## Cover of storage slot at front under roof liner (FF8) not fitting

Topic number	LI68.30-N-059117
Version	1
Design group	68.30 Coverings, trim
Date	05-27-2014
Validity	Model 906 with CODE FF8 (1 DIN slot at front under headliner)
Reason for change	
Reason for block

02.jpg:

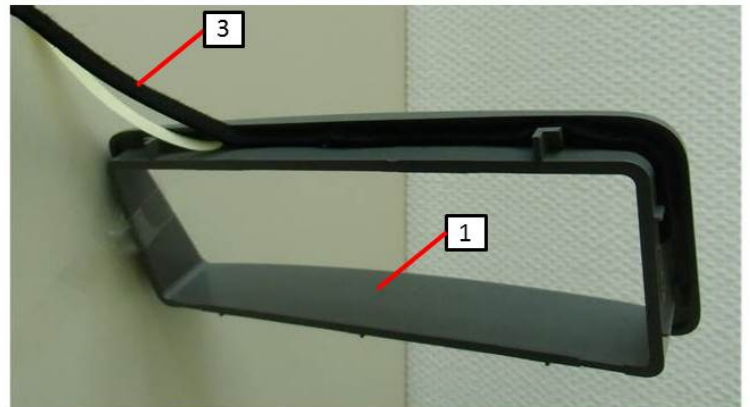
Cover (1) of storage slot at front under roof liner (FF8) not fitting.

Minimum dimensions of the cutout in roof liner is too large leading to an insufficient overlap by the cover (1) (A 906 695 0130).

1. Remove cover (2) or installed electrical equipment
2. Remove carrier
3. Unclip cover (1)
4. Cut felt strip (3) to size (dimensions: 240mm x 5mm)
5. Stick felt strip (3) onto bottom of cover (1) (see Figure 02 and Figure 03)
6. Assemble in the reverse order
